**STAFF RECOMMENDATION**  
**1209 Forrest Avenue**  
**December 16, 2015**

**Application:** Demolition

**Description of Project:** The applicant requests demolition of the structure due to fire damage suffered in March 2015.

**Appendix A: Sketch of Recommended Non-Fire-Related Repairs**

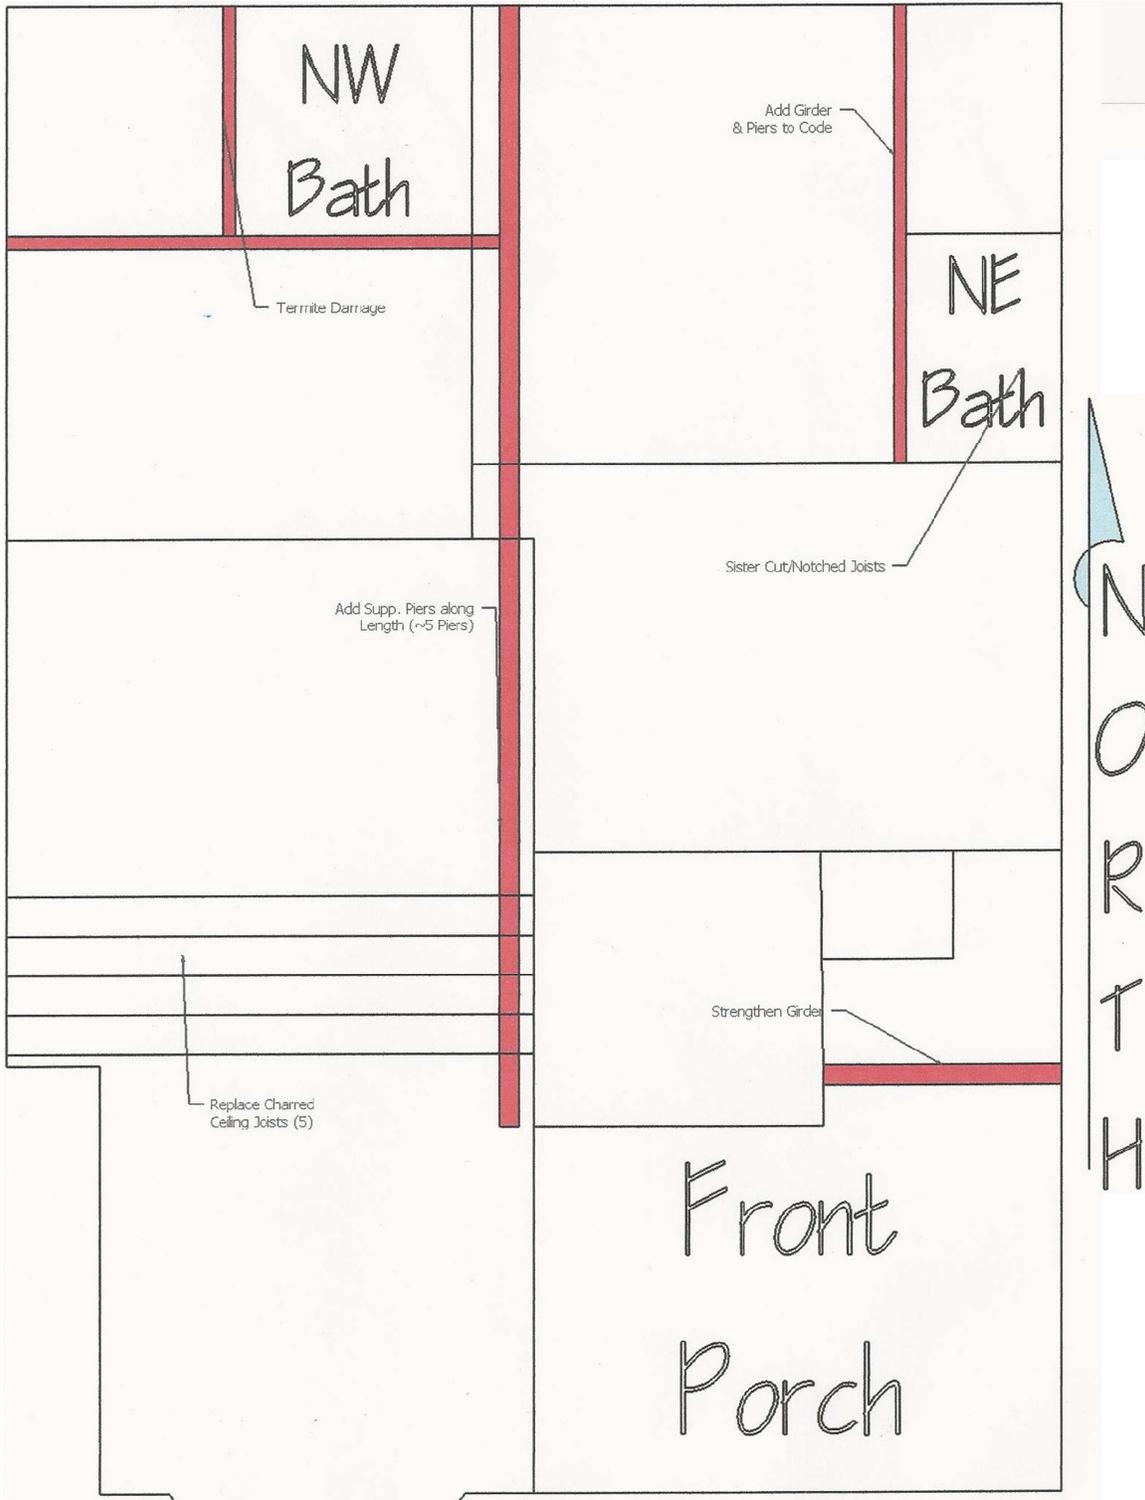
The existing pier supports for the center girder are in sound condition, but they are well overspanned according to typical design prescriptions. The overspanned girder has sagged (creeped) over time due to improper support. It is recommended to add supplemental piers between each of the existing piers to reduce the girder's span under code limits. This will require five additional piers along the center girder. At the time these piers are installed, it would be prudent to jack and shim the existing girders to recover some of the long-term creep of the girder to make the interior floors more level. The subfloor should be removed from the two small rooms on either side of the termite damage in the wall cavity at the northwest bathroom, at which time all termite-related damage should be replaced. The floor sags along the north/south partition wall at northeast bathroom; a supplemental girder should be installed to code standards under this wall, in addition to sistering any of the cut/notched joists. The girder between the front porch and the south exterior wall is a single 2x10 member that should be sistered with another 2x10 for additional strength. The following Appendix A is a sketch of the house footprint and areas requiring non-fire-related repair to restore the integrity of the structure to a safe and better-than-before condition.
